## Evaluation of the Predictive Ecological Model for the Edwards Aquifer Habitat Conservation Plan: An Interim Report as Part of Phase 2

***Evaluation of the Predictive Ecological Model for the  
Edwards Aquifer Habitat Conservation Plan:  
An Interim Report as Part of Phase 2***

Committee to Review the Edwards Aquifer Habitat Conservation Plan

FIGURE 1 Three common spawner–recruit relationships: (A) Ricker, (B) Beverton-Holt, (C) Cushing. SOURCE: Figure 10 from Parrish and MacCall (1978).

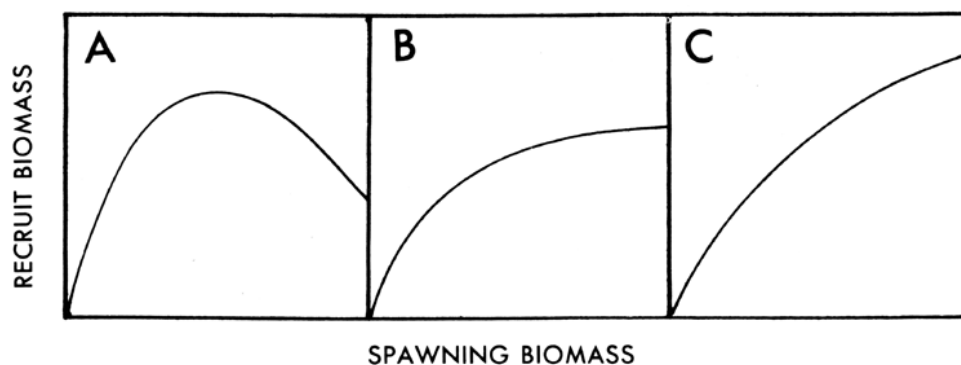
However density-dependent is represented, when all effects are simulated on individuals it is important to show how these effects add up to density-dependence mortality at the population-level. For example, a typical diagnostic to use is showing the annual spawner–recruit plot that results from multiple years of simulation. A common measure of spawners is total eggs produced in a year, and a common measure of recruitment would be the number of individuals that survived from those eggs to become juveniles and then to become adults. This can be difficult with a species like FD that spawns all year long and for which the present formulation includes density-dependence in the adult stage; defining over what months to sum egg production and how to accumulate recruits to obtain annual values needs to be considered. In addition, because of its potential importance on population dynamics, the density-dependence in adults should also be characterized and quantified. Based on the life history of the FD, one would expect a Beverton-Holt type spawner–recruit relationship, likely with a weak response (gradually leveling off curve, Figure 1B). One often characterizes these curves with the steepness coefficient that summarizes the strength of the density-dependence in the spawner–recruit relationship, which has been reported for hundreds of fish species (e.g., Rose et al., 2001). Based on the Committee’s experience, a steepness value of 0.5 to 0.7 is anticipated. One could also try to create a spawner–recruit curve using proxies from the field data and compare its properties (e.g., shape) to the model predictions. Some additional exploration of how density-dependence manifests itself at the population-level is needed.
